## Land Use Application Updates (per 2/28/23 email)

LAND USE APPLICATION  
3/10/2023

1 ZONE A LAYOUT/MATERIALS  
1" = 20'-0"

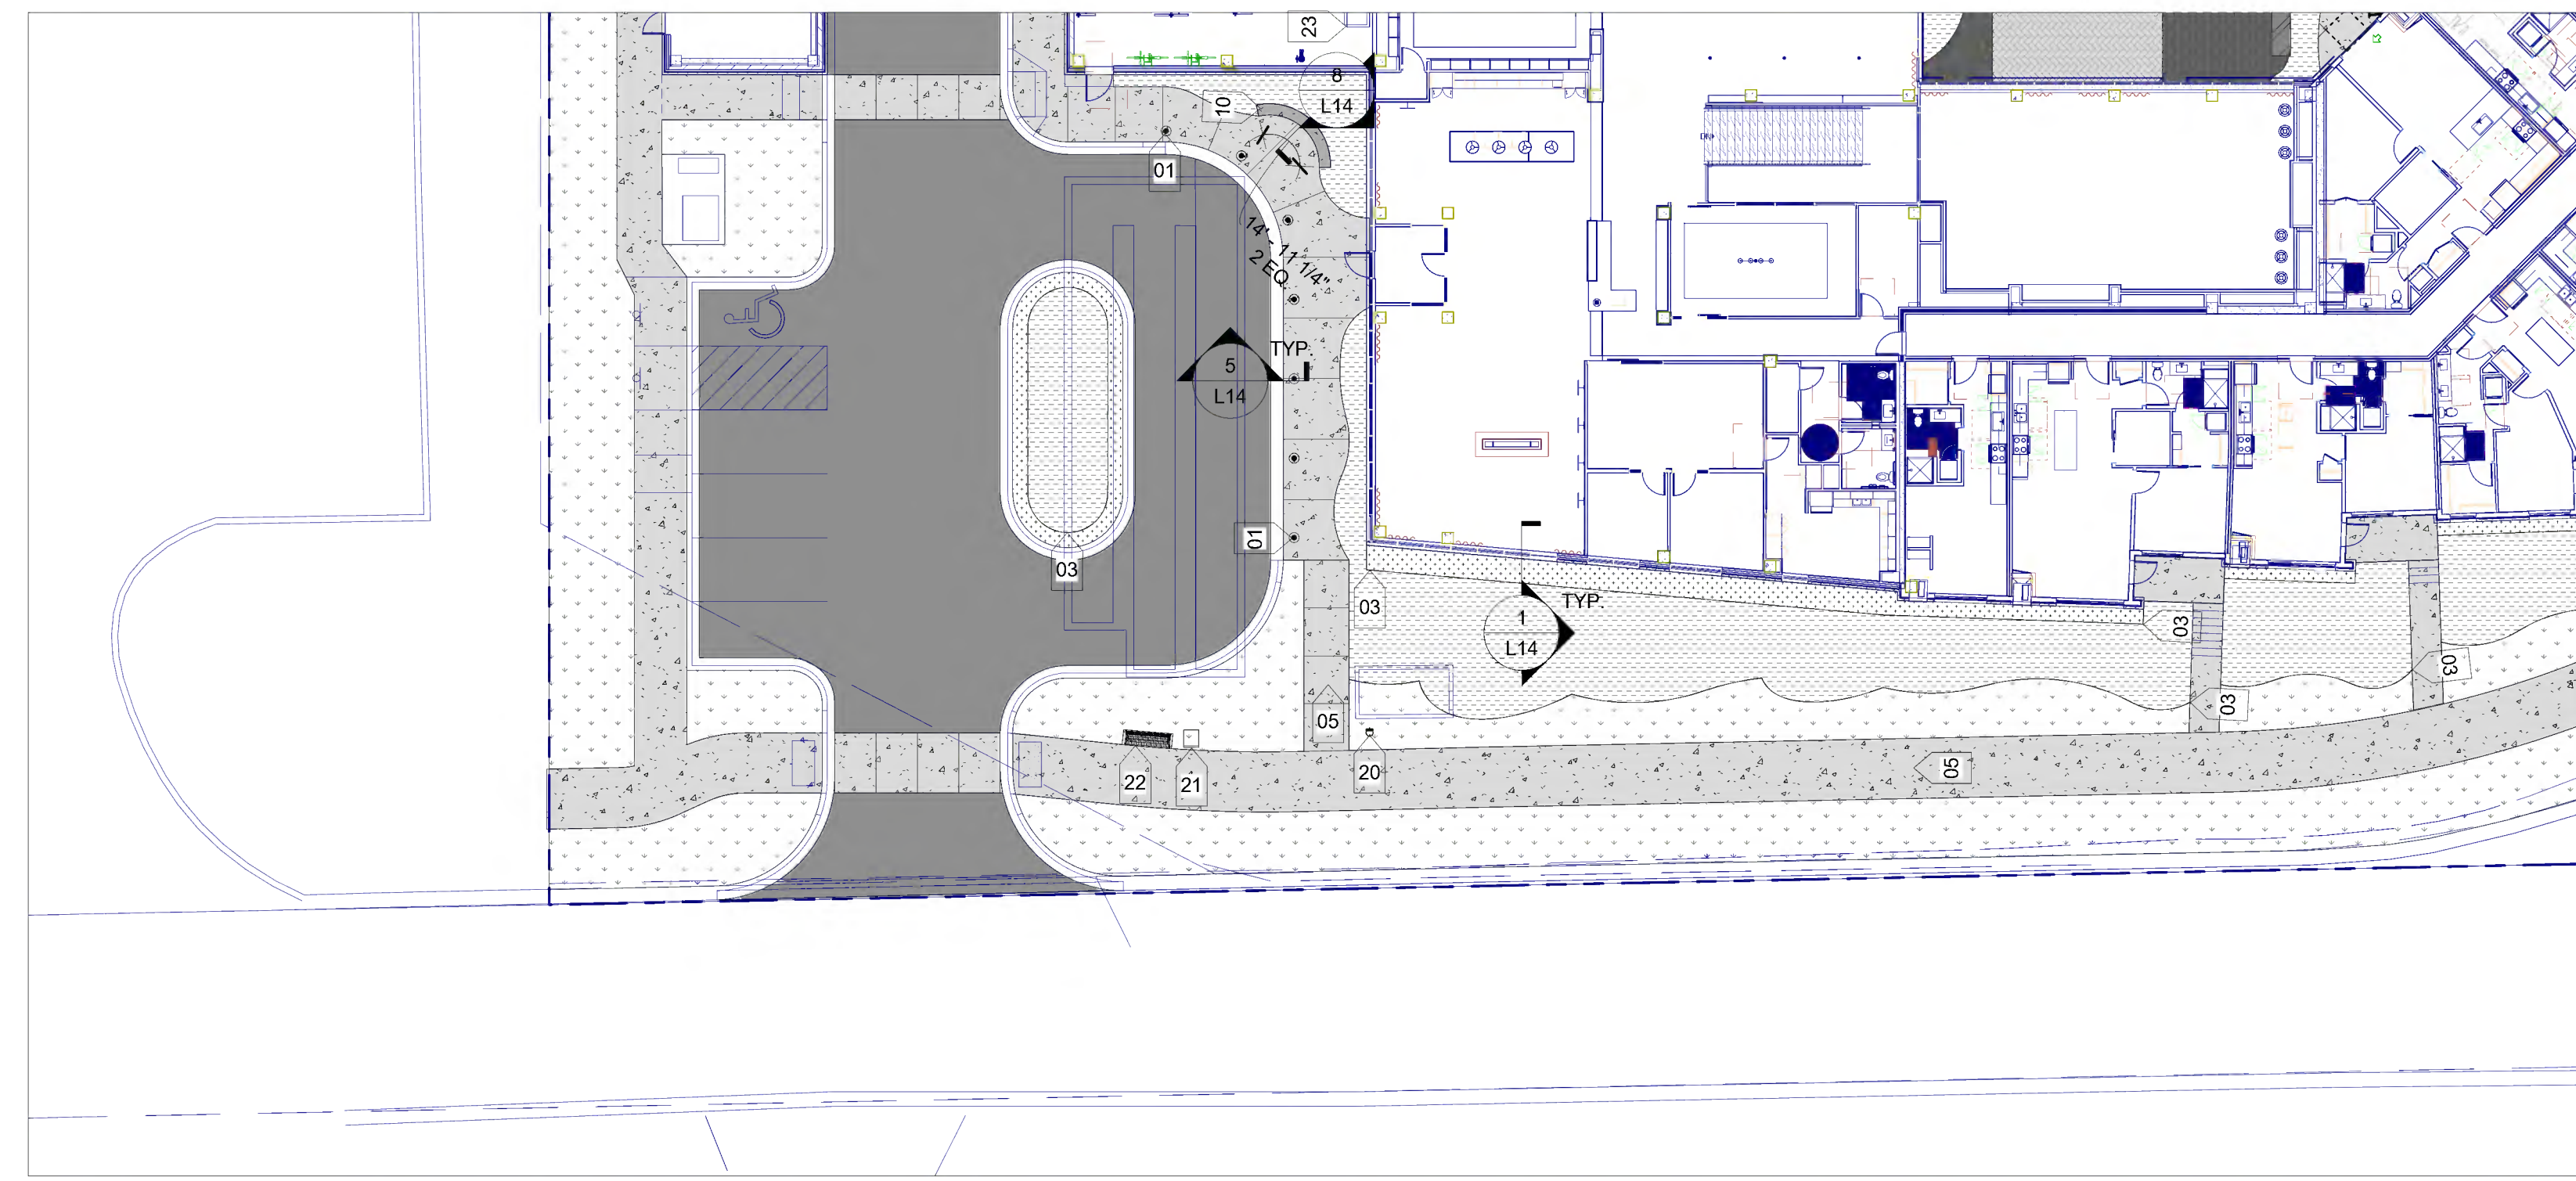
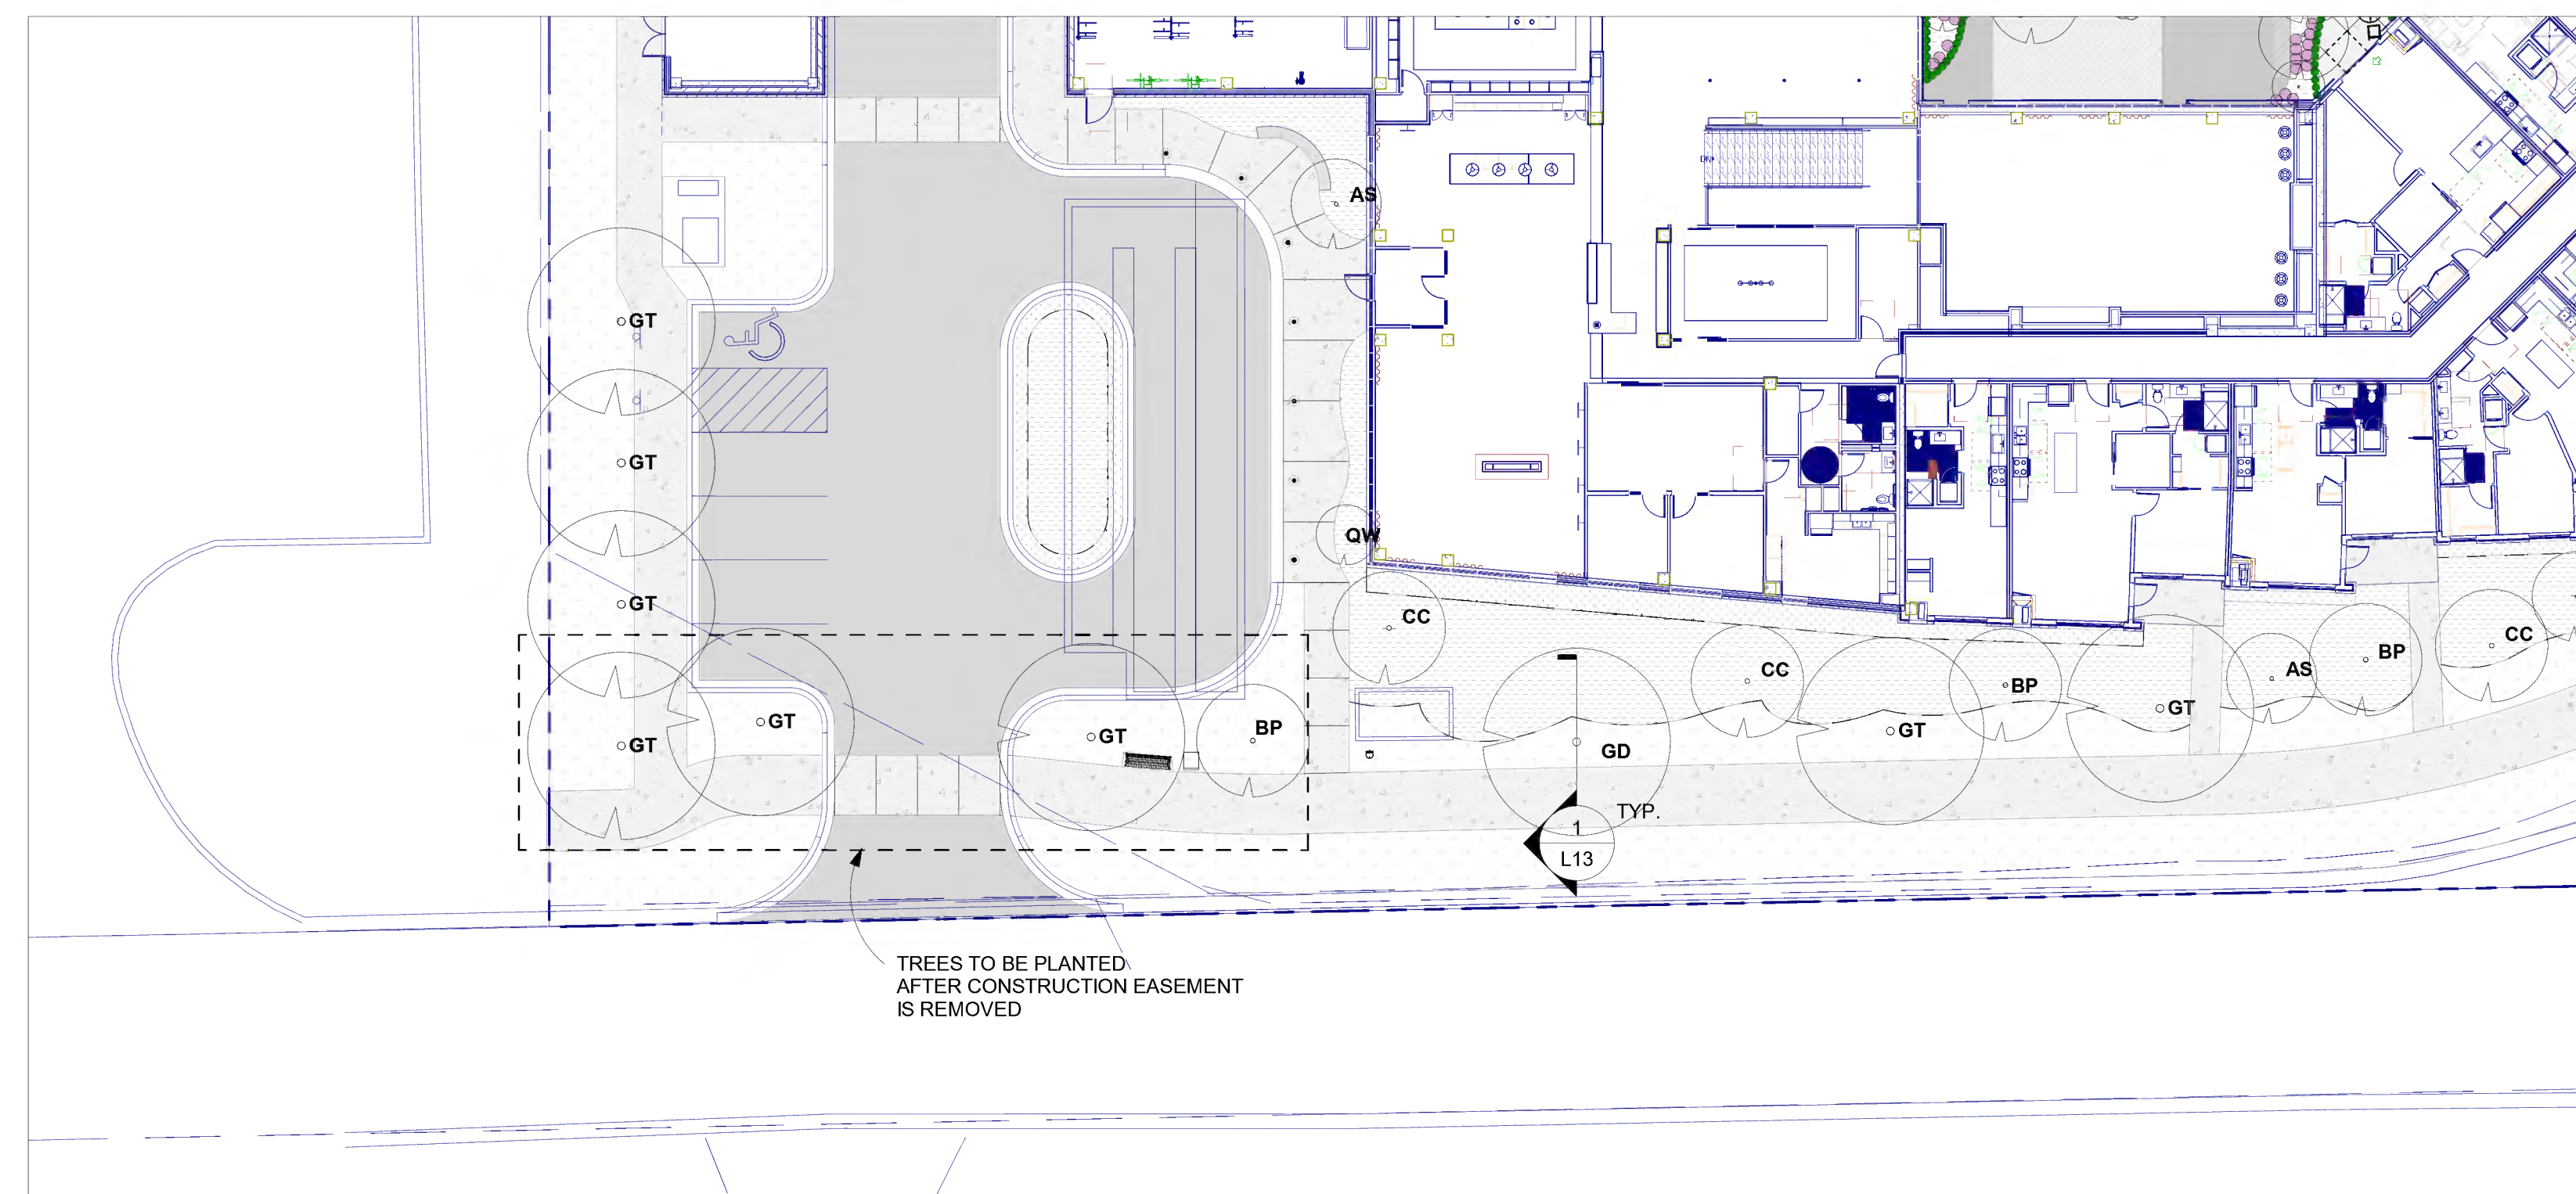
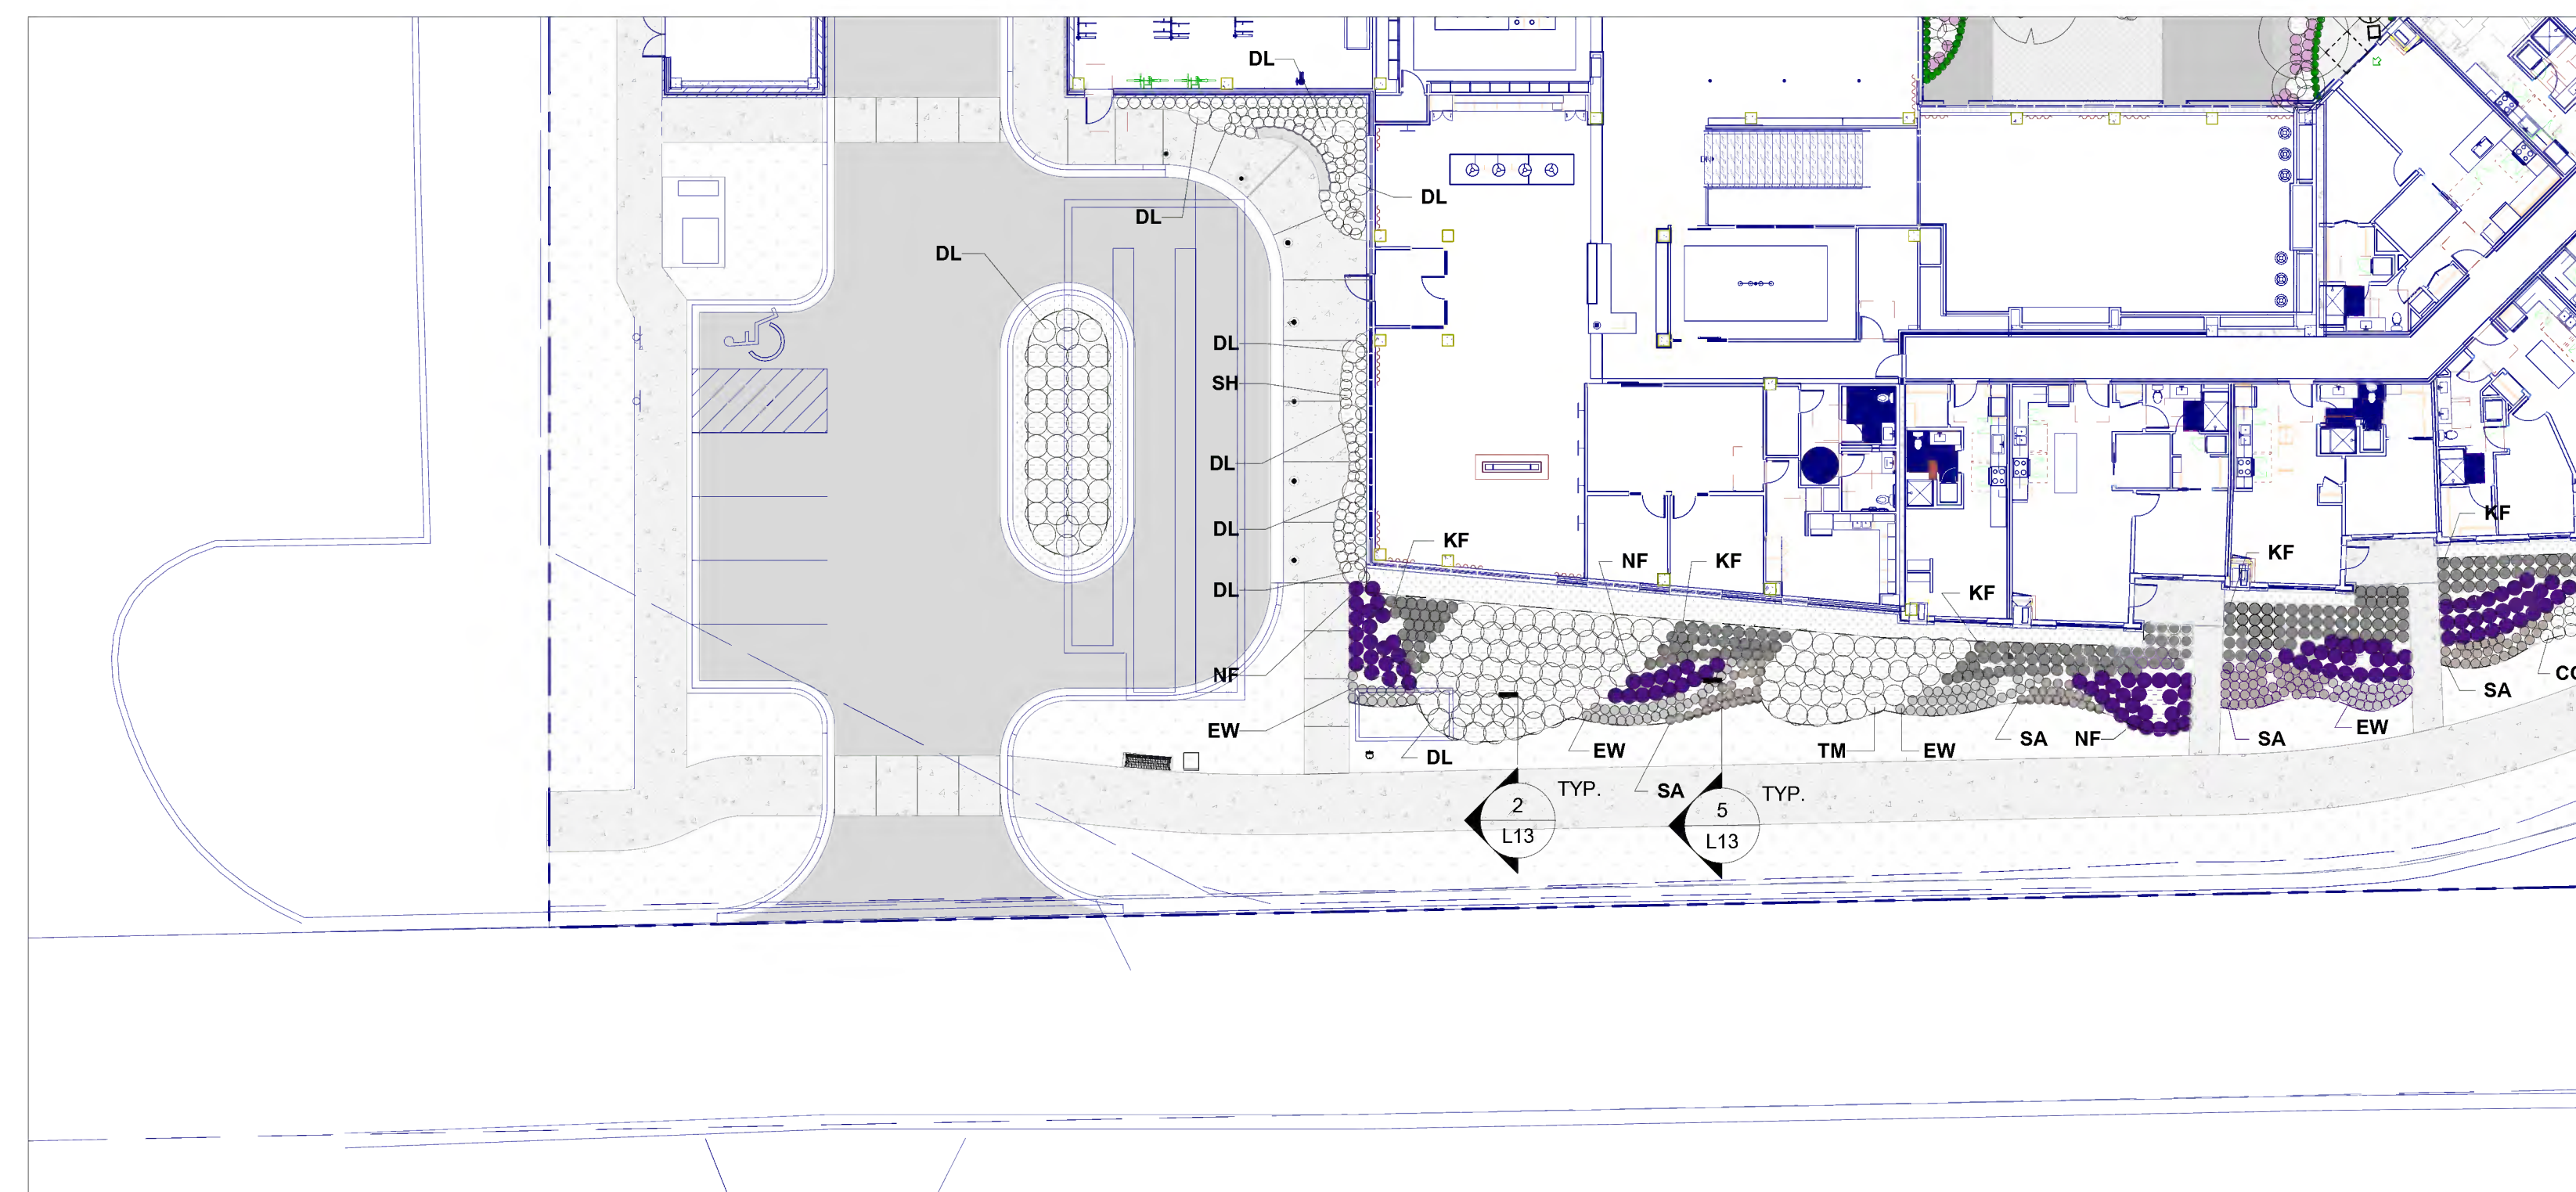
The plan must also incorporate pedestrian furniture, wayfinding signage from the Opus placemaking guide and dog waste bags. See top exhibit of L3 sheet, left exhibit of L4 sheet, and left exhibit of L5 sheet.
